Accredited Standards Committee  
X3, Information Processing Systems

Doc: X3T10.1/96a126r0  
Date: February 28, 1996  
Project: X3T10.1 / 1145  
Ref Doc.: SSA-PH1 rev 8  
Reply to: Bill Ham, DEC

Subject: Proposal to modify clause G.1 (wiring board design)

Figure G.1 - Line path definitions

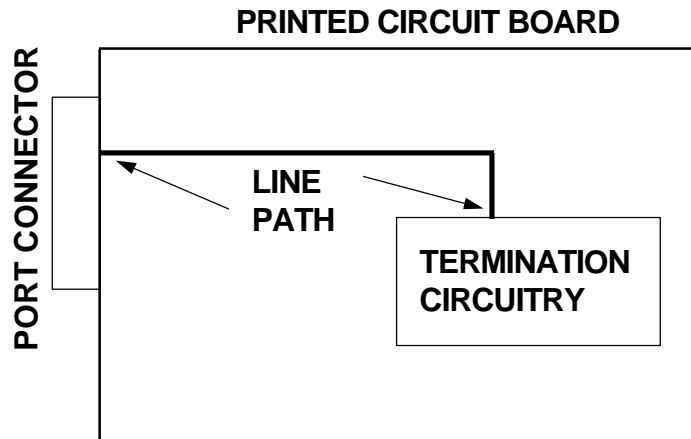
- a) Line path: The electrical conductor between the port connector and the termination circuitry, commonly the termination resistor (see **Error! Reference source not found.**).
- b) Line + path: The line path for the + signal.
- c) Line - path: The line path for the - signal.
- d) Stub: Any electrical path connecting to the line path but not part of the line path (See Figure G.2).

Figure G.2- Stub examples

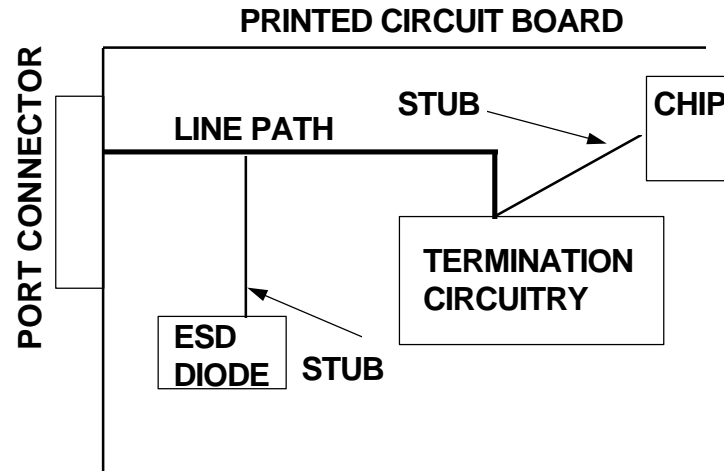
- Isolate other active signals from the line path on the printed circuit board.
- Stubs should be minimized and not exceed 0,5 inch in length.
- Capacitance to ground on stubs should be minimized.
- Line + paths and line - paths should be laid out as 75 ohm single ended traces on one signal layer, preferably on top or bottom layers.
- Isolate SSA ports from each other.
